Access Compliance Report

Public Rights-of-Way

Intersection ID: 28659	Main Street: HAMPTON_PLACE_DR	Cross Street: RIDGELINE_LN	Location: W
ADA ID: 04A32FF6A518	Ramp Type: PerpDiag	Initial Pass/Fail: Fail	Overall Compliance: No
		Severity Score: 10

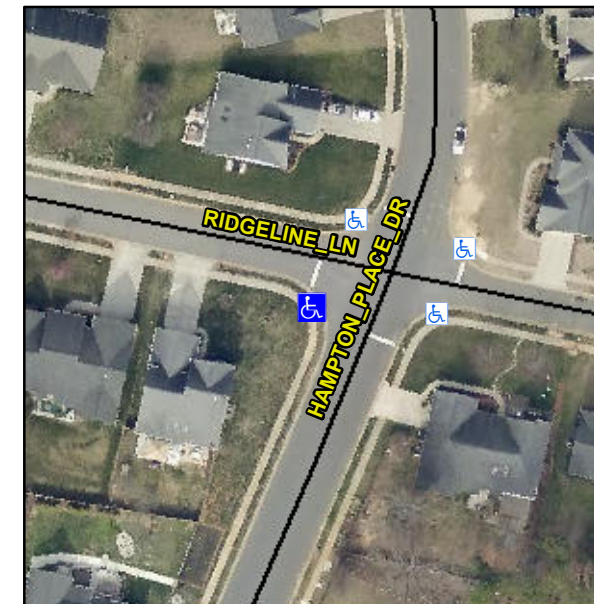
R304.5.1, R304.5.3

Compliance	Description	Data	Compliance	Description	Data
N/A	Ramp Length (in)	48.5	Yes	Ramp Slope (%)	5.7
No	Ramp Width (in)	47.5	No	Ramp XSlope (%)	3.8
N/A	Flare Type LT	N/A	N/A	Flare Type RT	N/A
N/A	Flare Slope LT (%)	N/A	N/A	Flare Slope RT (%)	N/A
N/A	Flare Traversable LT?	N/A	N/A	Flare Traversable RT?	N/A
N/A	Landing Length (in)	N/A	N/A	DWS Provided?	N/A
N/A	Landing Width (in)	N/A	N/A	DWS Contrast?	N/A
N/A	Landing Slope (%)	N/A	N/A	DWS Length (in)	N/A
N/A	Landing X Slope (%)	N/A	N/A	DWS Full Width?	N/A
N/A	Landing Curb? (Y/N)	N/A	N/A	DWS Offset (in)	N/A
N/A	Shared Landing?	N/A			
N/A	Gutter Ponding?	N/A	N/A	Gutter Slope (%)	N/A
N/A	Gutter Lip Ht (in)	N/A	N/A	Gutter X Slope (%)	N/A
N/A	Painted X Walk1?	No	N/A	Painted X Walk2?	No
	X Walk 1 Direction	To E		X Walk 2 Direction	To NE
N/A	X Walk 1 Width (in)	N/A	N/A	X Walk 2 Width (in)	N/A
	X Walk 1 Slope (%)	3.0		X Walk 2 Slope (%)	2.6
	X Walk 1 X Slope (%)	4.8		X Walk 2 X Slope (%)	4.1

Remove & Replace Curb Ramp With Two New Directional Ramps or Equivalent.
